**REFERENCE NUMBER: SPD3/2021/030**

**TENDER FOR THE DESIGN, SUPPLY, DELIVERY AND INSTALLATION OF LABORATORY FURNITURE AT THE GOVERNMENT EXPERIMENTAL FARM, MINISTRY FOR GOZO, IN THE CONTEXT OF THE INTERREG ITALIA-MALTA SIMASEED PROJECT - SIMASEED PROCUREMENT 8 (2021)**

**Clarification No. 3**

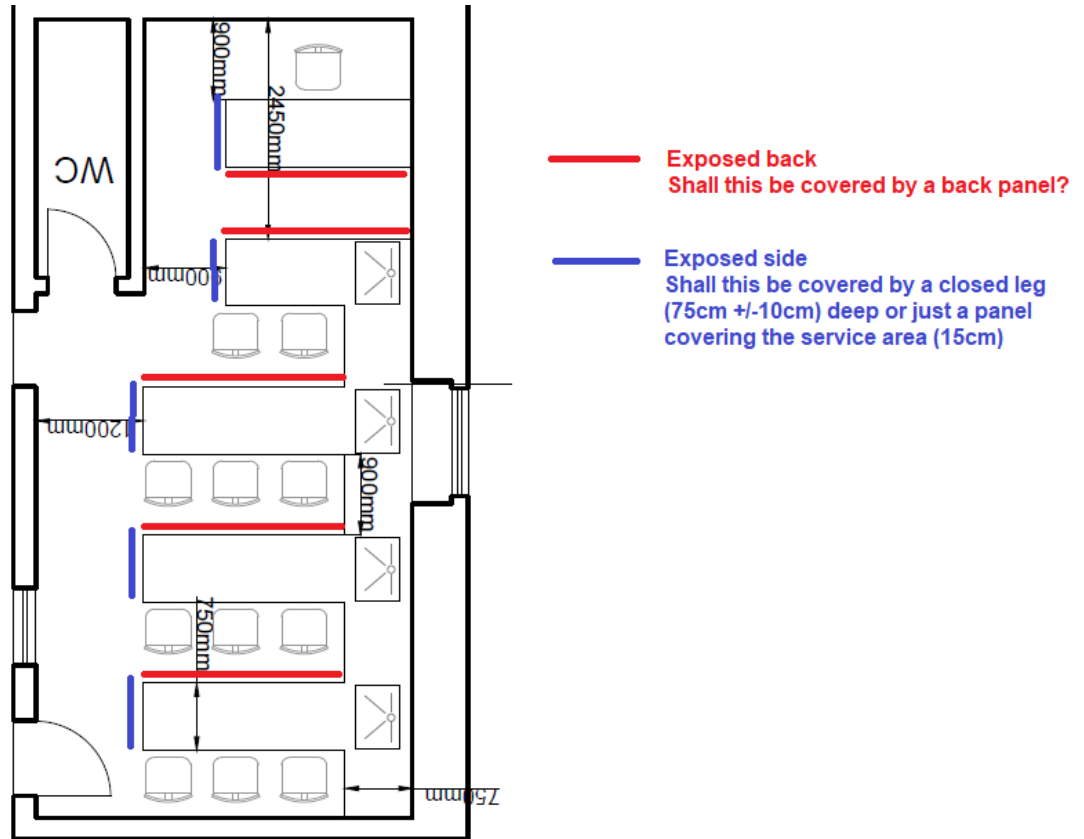
Question 2: Please confirm that bidders are to quote also for 5 in no. back panels for instances where the back of a bench is exposed as shown below;

**Answer 2:** This is being confirmed.
